Decision 15-01-005 January 15, 2015

BEFORE THE PUBLIC UTILITIES COMMISSION OF THE STATE OF CALIFORNIA

Rulemaking 14-08-012
(Filed August 14, 2014)

DECISION AMENDING GENERAL ORDER 95

D. Risers

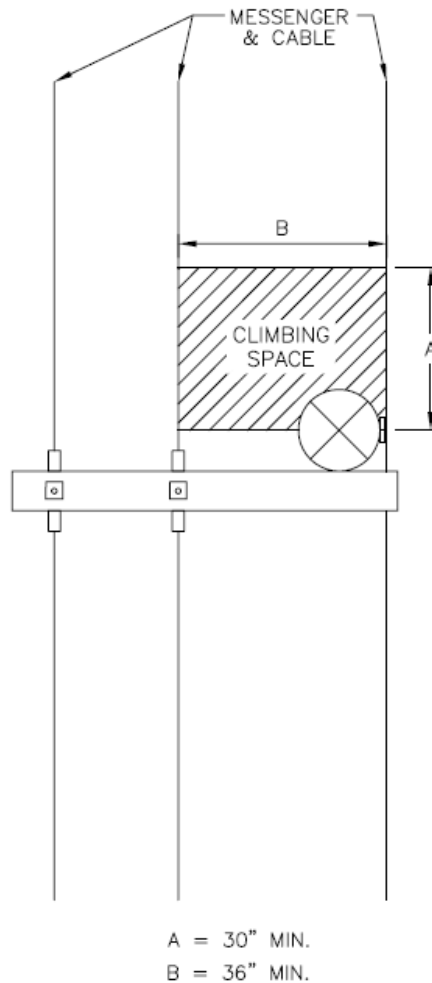
This proposed rule change and associated revisions to Rule 91.4 provide uniform requirements for installing riser brackets. The reason for establishing an installation height for the lowest riser support bracket at eight (8) feet above the ground line and foreign structures is to prevent easy climbing of utility poles.

(3) Hardware (See Rule 91.4).

Figure 84-2

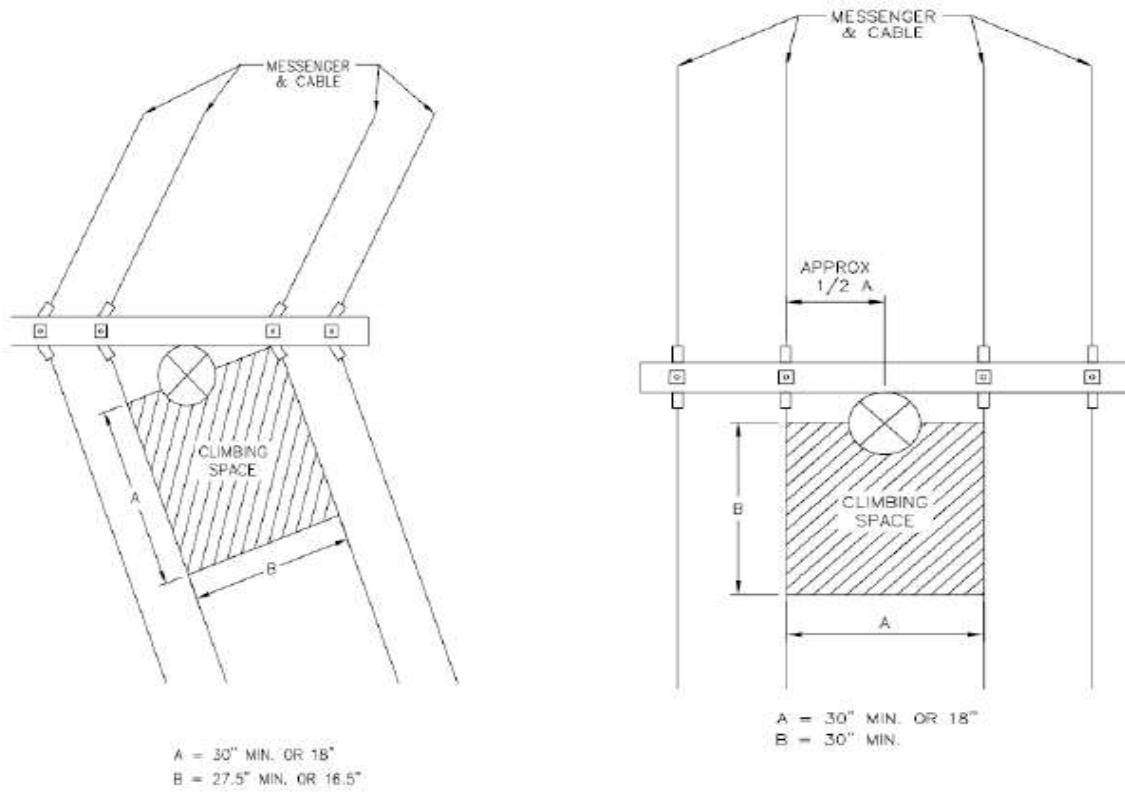
This proposed rule change adds a new diagram (shown above) to Figure 84-2 that reflects a modern construction practice. All of the existing Figure 84-2 (including a diagram – not shown above - of open wire communication conductors supported on crossarms) is retained.

**Rule 84.7-B
Figure 84-4**

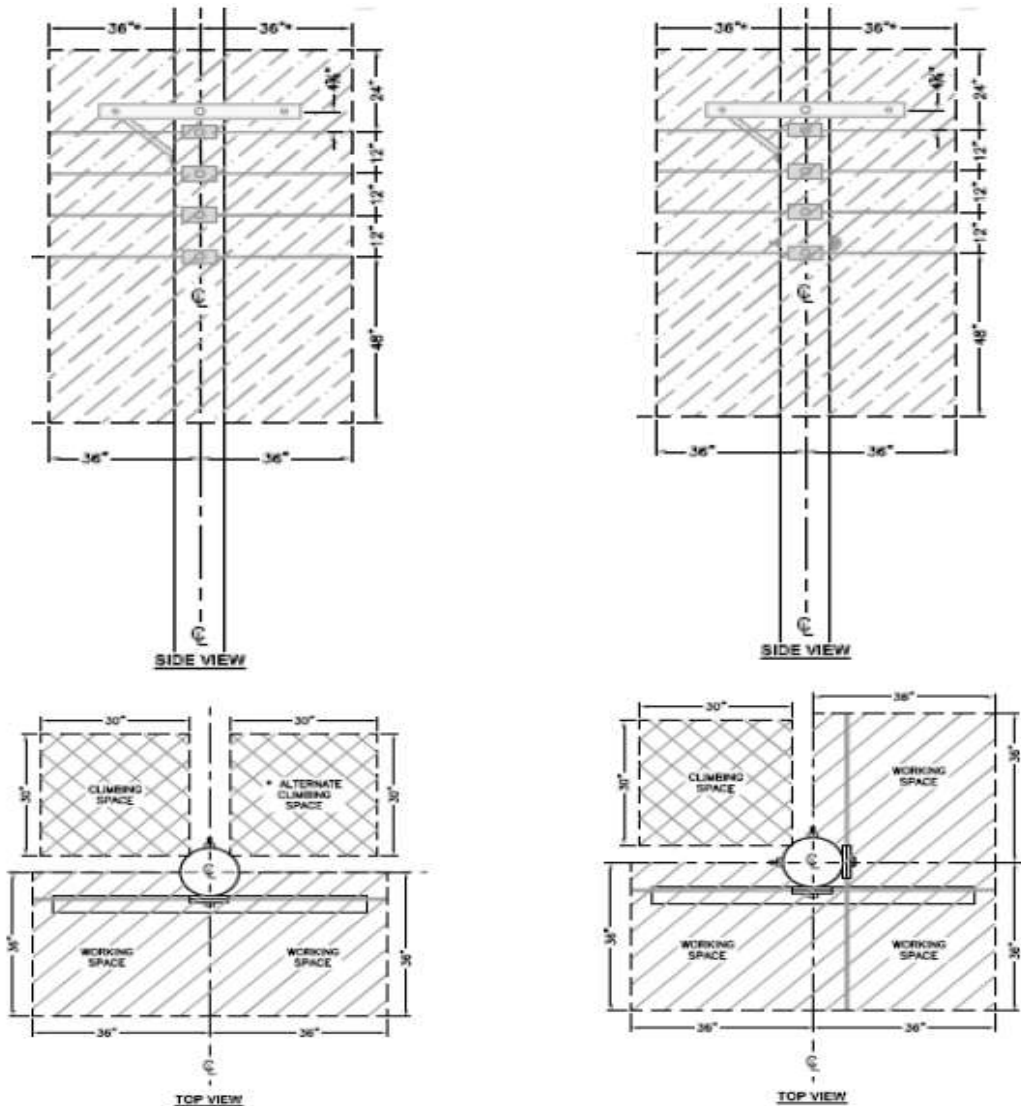
Although the existing clearance and separation rules in Section III and Section VIII for communication conductors create theoretical “working space,” inconsistent interpretation and application of existing rules purportedly produces inconsistent results and often limits or prohibits the application of safe work methods. The working space in proposed new Rule 84.7-B, as depicted in proposed new Figure 84-4 above, is intended to improve worker safety by better defining the work environment for persons responsible for constructing and maintaining communication lines.

Figure 84-~~45~~

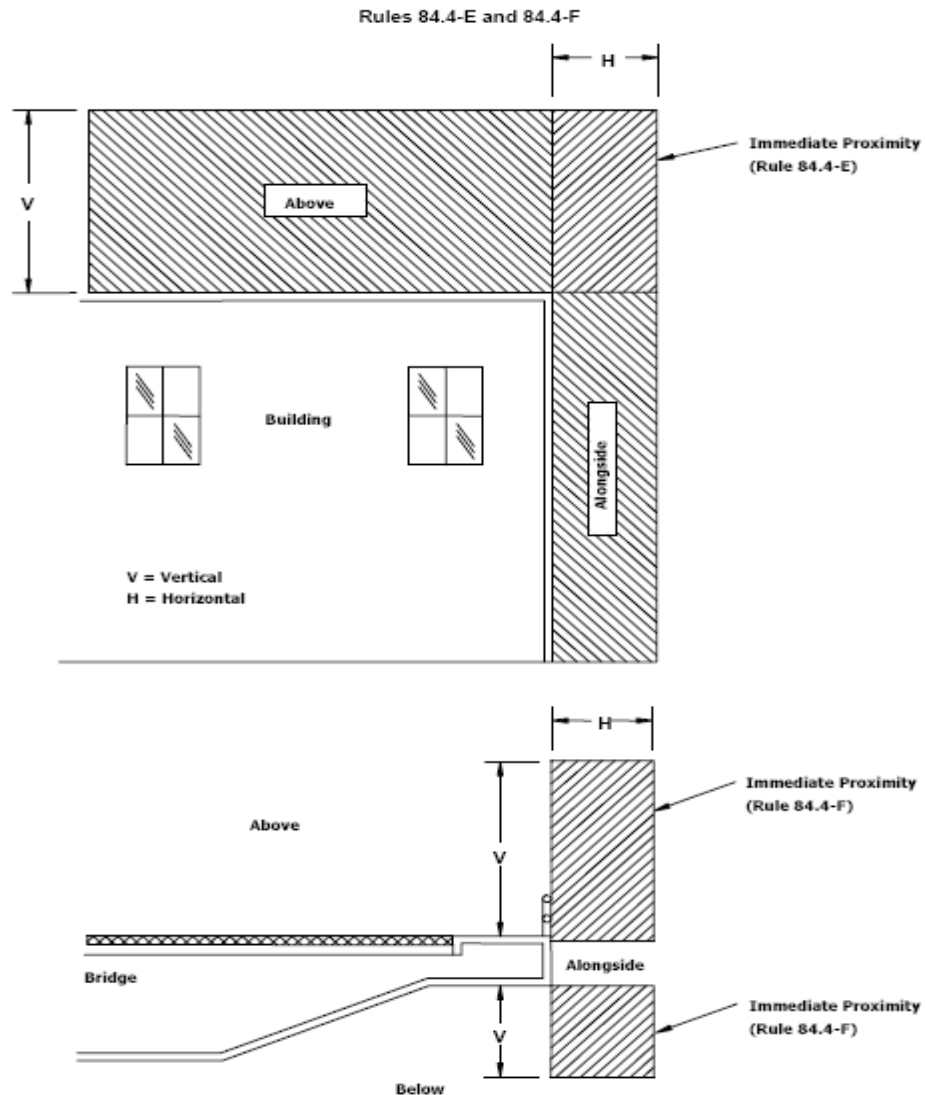
The previous Proposed Rule Change (PRC) 13 adds a new Figure 84-4. In PRC 14, above, the existing Figure 84-4 renumbered as Figure 84-5. There are no other changes to the renumbered Figure 84-5.

Figure 84-2

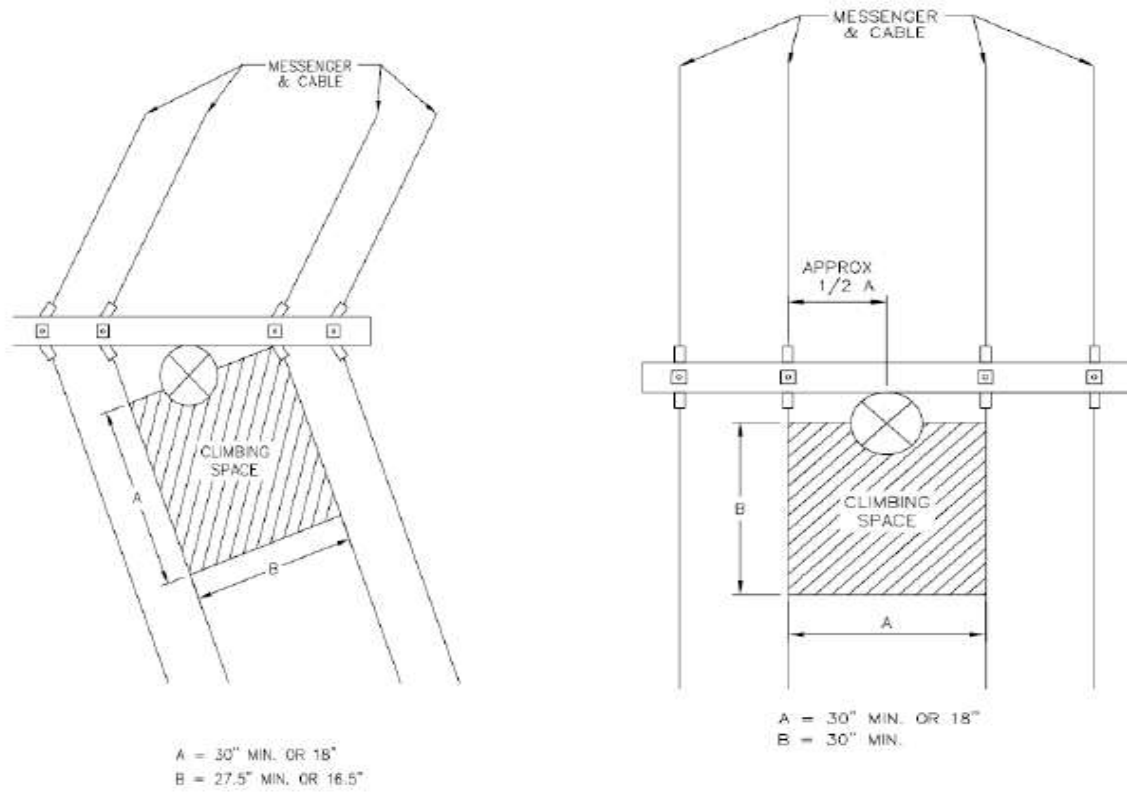
This proposed rule change adds a new diagram (shown above) to Figure 84-2 that reflects a modern construction practice. All of the existing Figure 84-2 (including a diagram – not shown above - of open wire communication conductors supported on crossarms) is retained.

Figure 84-3

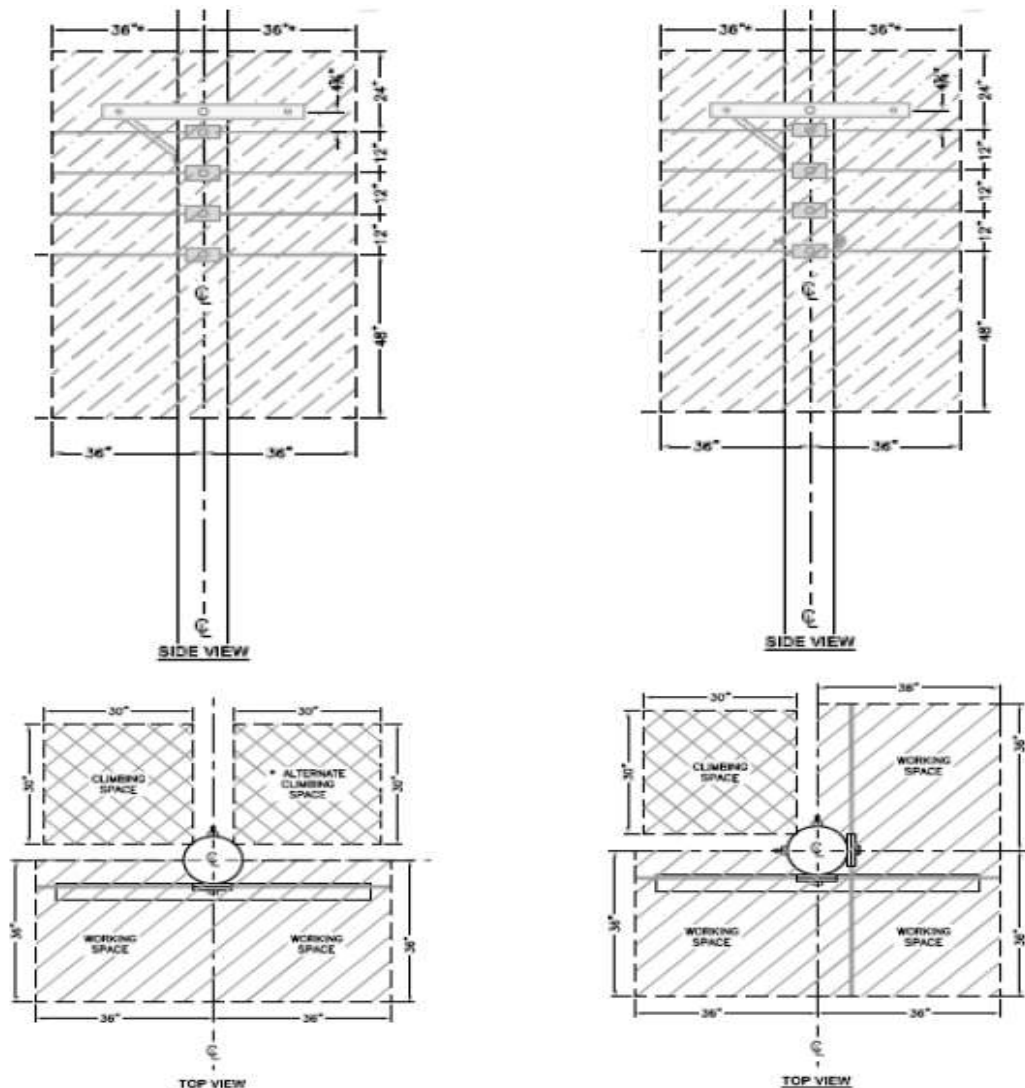
This proposed rule change adds a new diagram (shown above) to Figure 84-3 that reflects a modern construction practice. All of the existing Figure 84-3 (including a diagram – not shown above – of open wire communication conductors supported on crossarms) is retained.

Figure 84-~~4~~5

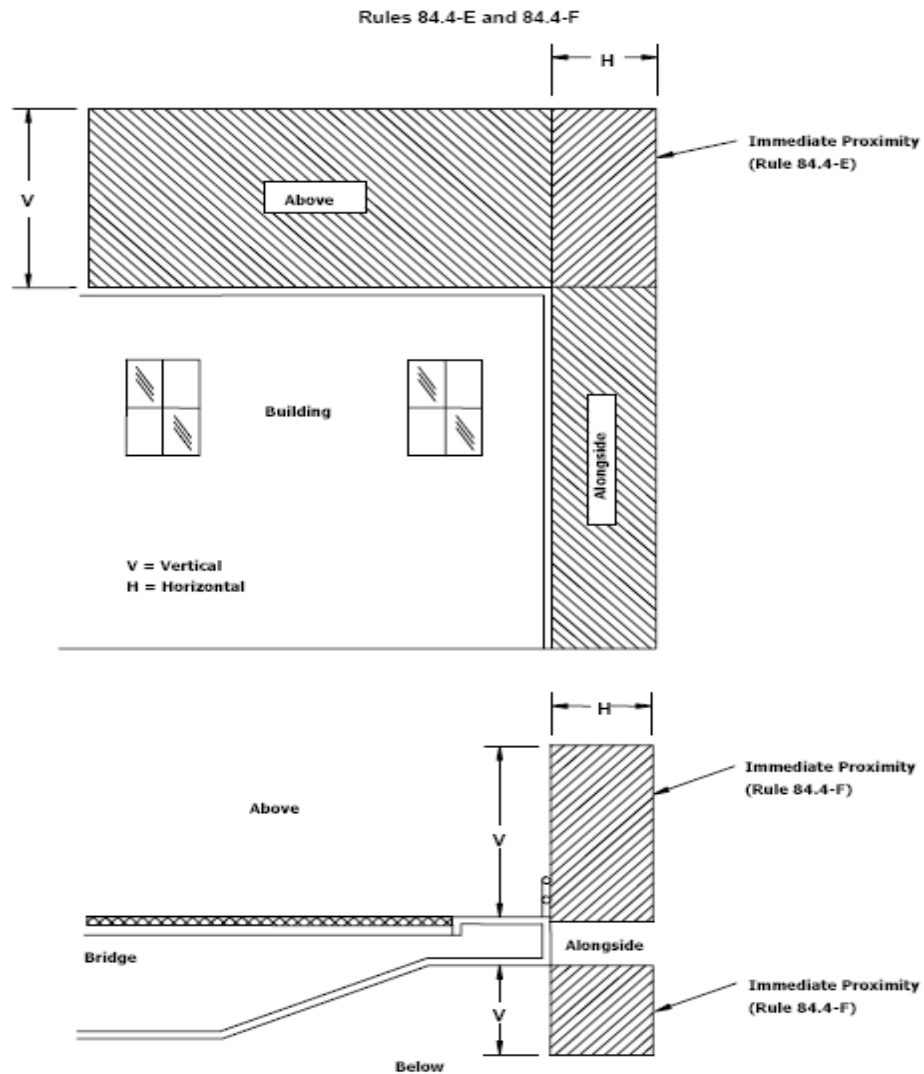
The previous Proposed Rule Change (PRC) 13 adds a new Figure 84-4. In PRC 14, above, the existing Figure 84-4 is renumbered as Figure 84-5. There are no other changes to the renumbered Figure 84-5.

Figure 10
Minimum Vertical Separation in Linearm and Buckarm Construction

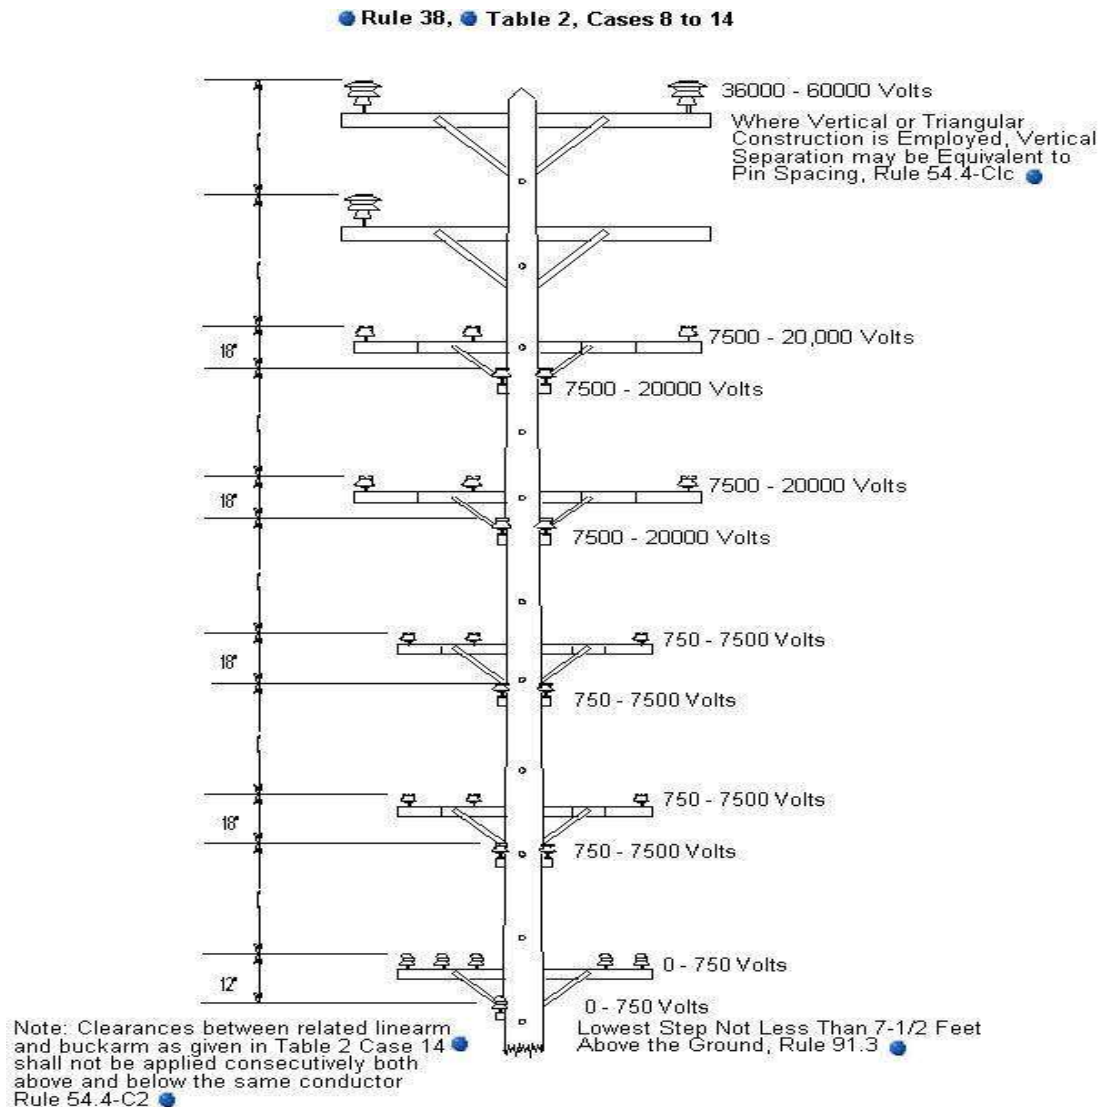
Strike the following text from Appendix G, Figure 10 - ~~“Lowest Step Not Less Than 7-1/2 Feet Above Ground, Rule 91.3”~~

The purpose of this revision is to remove unrelated and unnecessary text from Figure 10.

Figure 11
Minimum Vertical Separation in Combination Linearm and Combination Buckarm Construction

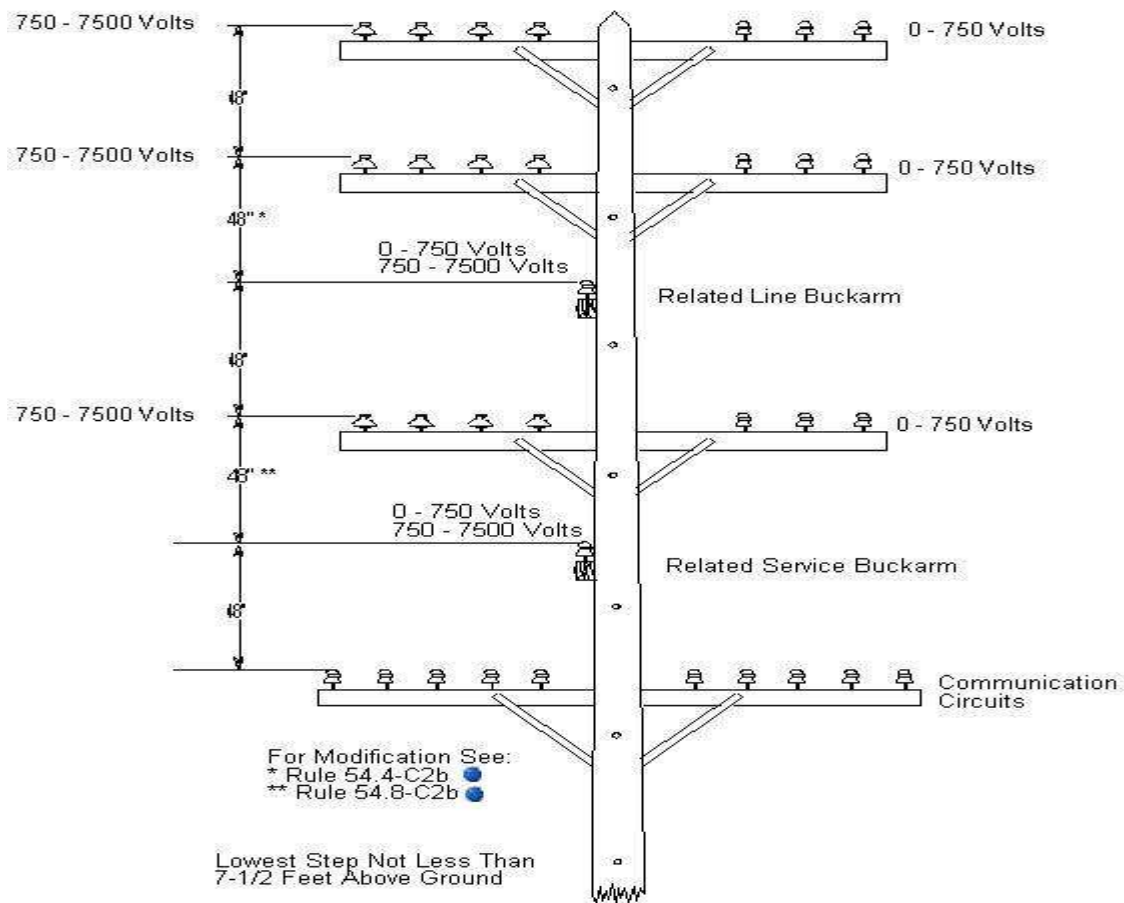
Strike the following verbiage from Appendix G, Figure 11 – ~~“Lowest Step Not Less Than 7 ½ Feet Above Ground”~~

The purpose of this revision is to remove unrelated and unnecessary text from Figure 11.
